ADDENDUM No. 2

Hayden Area Regional Sewer Board (HARSB)
HARSB Phase 2 Tertiary Treatment and Biosolids Project
Kootenai County, Idaho

August 13, 2021

DRAWING CU00-001

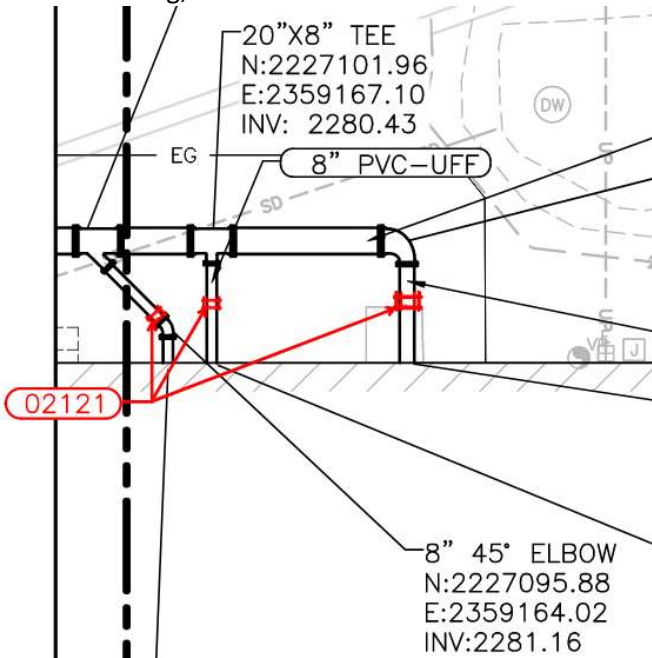
Add Notes 21 and 22 to the Yard Piping Notes as follows:

“21. At the Contractor’s option, a DI piping system with CM lining may be used in lieu of the following buried PVC piping systems called out on the plans: Overflow (OF), Potable Water (PW), Secondary Effluent (SE), Ultra Filtration Filtrate (UFF), Utility Water (UW). Refer to sheet G00-013.

22. At the Contractor’s option, a DI piping system with Epoxy lining may be used in lieu of the following buried PVC piping systems called out on the plans: Drainage Force Main (FM), Solids Contact Clarifier Effluent (SCCE), Tertiary Equalization Influent / Return (TEI / TER), Waste Activated Sludge (WAS). Refer to sheet G00-013.”

DRAWING CU00-110

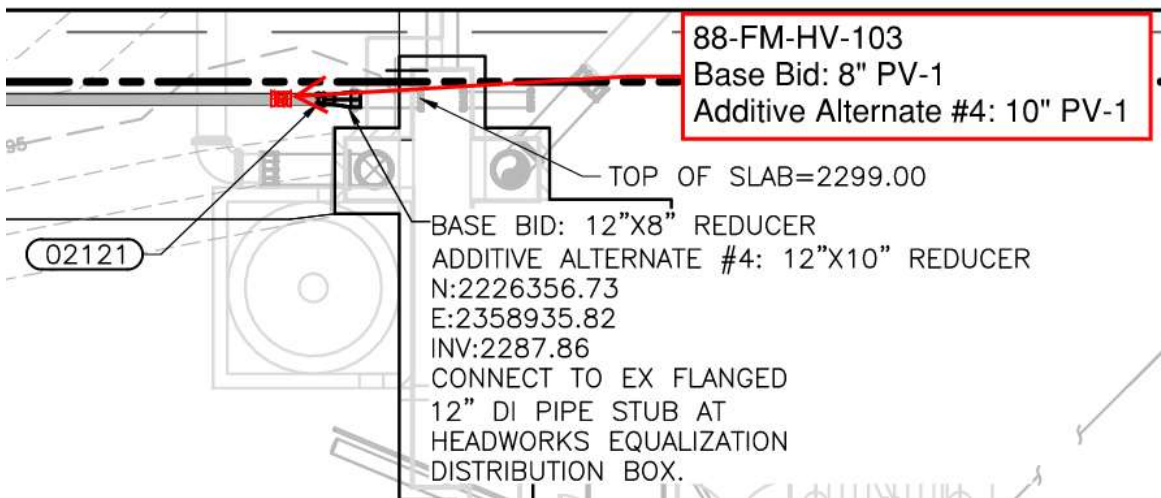
Add new valve 88-FM-HV-103 to the on the FM line to the west of the Headworks structure as shown below. Valve will be type PV-1 and will be 8" diameter for the base bid, but 10" diameter for Additive Alternate #4.

DRAWING D80-101, I80-701 and E80-101

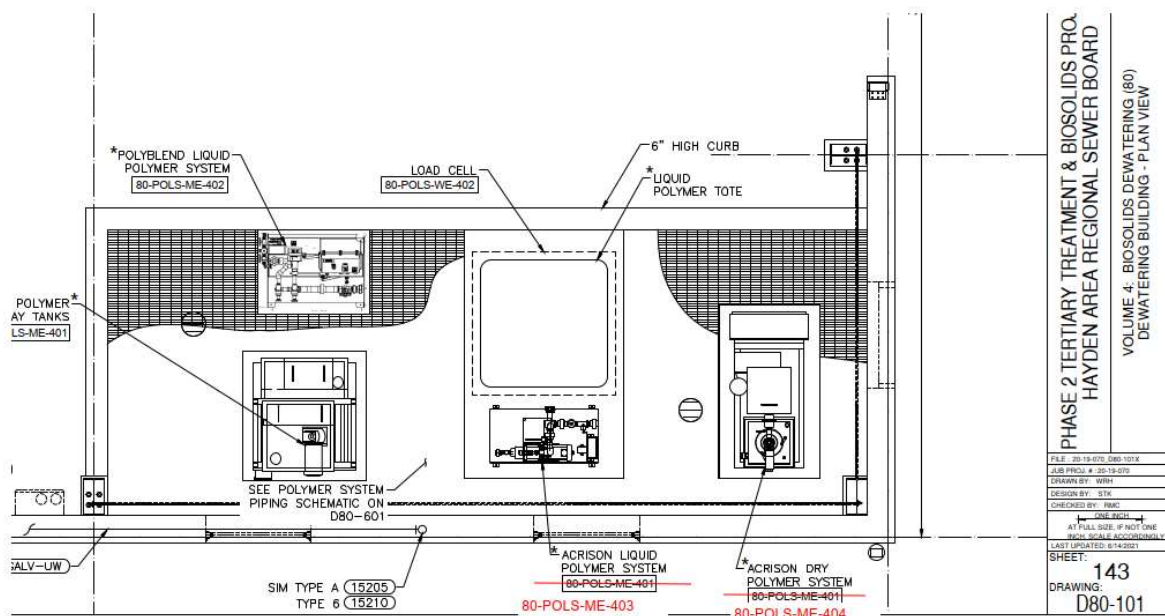
- Revise all instances of the "Acrison Liquid Polymer System" equipment tag from 80-POLS-ME-401 to 80-POLS-ME-403
- Revise all instances of the "Acrison Dry Polymer System" equipment tag from 80-POLS-ME-401 to 80-POLS-ME-404
- See Markups Below for Reference:
